# **Public Hearing to Consider Advanced Clean Cars II Regulations**

## **Final Statement of Reasons for Rulemaking, Including Summary of Comments and Agency Response**

### **Appendix B Summary of Comments to the Low-Emission Vehicle Regulation and Agency Response**

*Public Hearing Date: August 25, 2022  
Agenda Item No.: 22-10-1*

**Figure 1:** CARB test data<sup>21, 22, 23</sup> of chassis-certified gasoline MDVs tested on-road using PEMS and evaluated using the MAW analysis method. The emissions for each standard are shown for the corresponding model year and each bar represents the emissions for that test on each route.

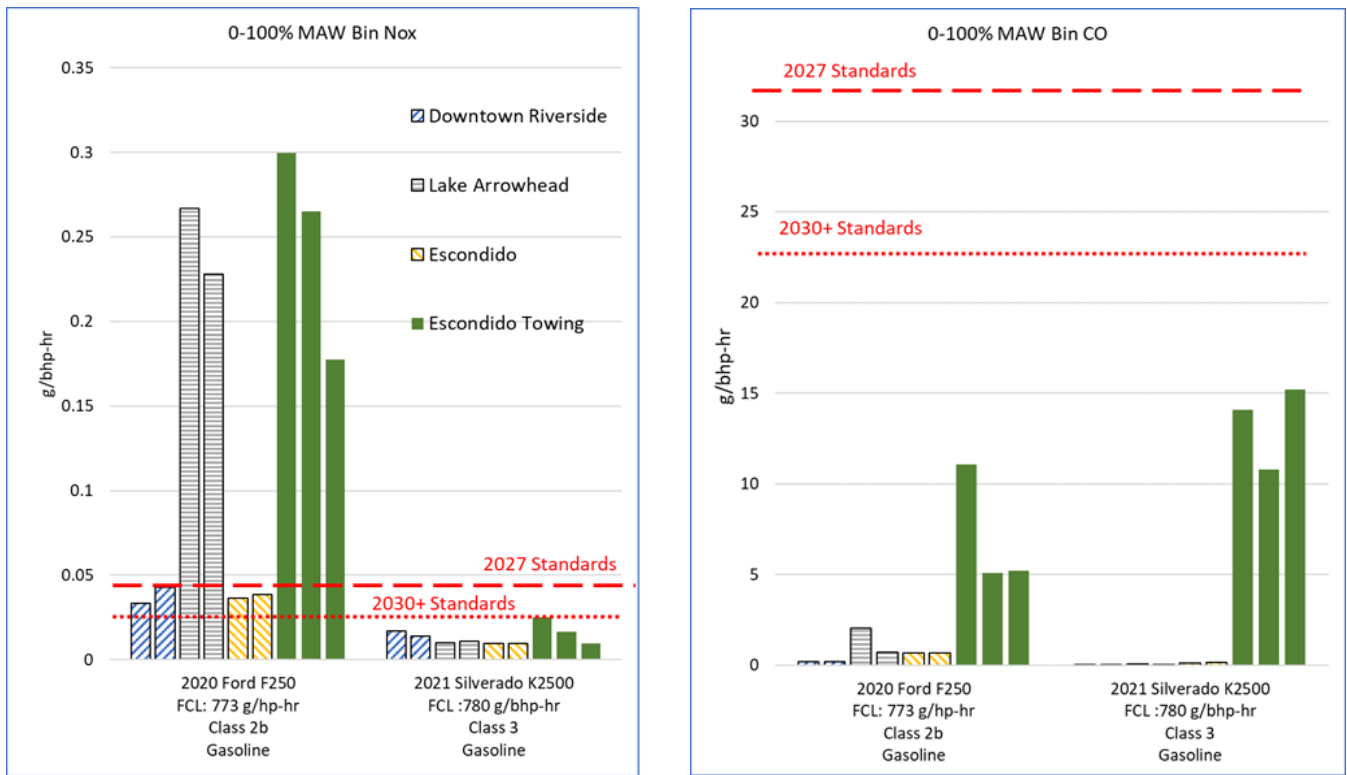
3. Comment: Commenter believes ACC II MDV PEMS data did not demonstrate the feasibility of meeting the MAW standards with a vehicle. [OP-92, OP-95]
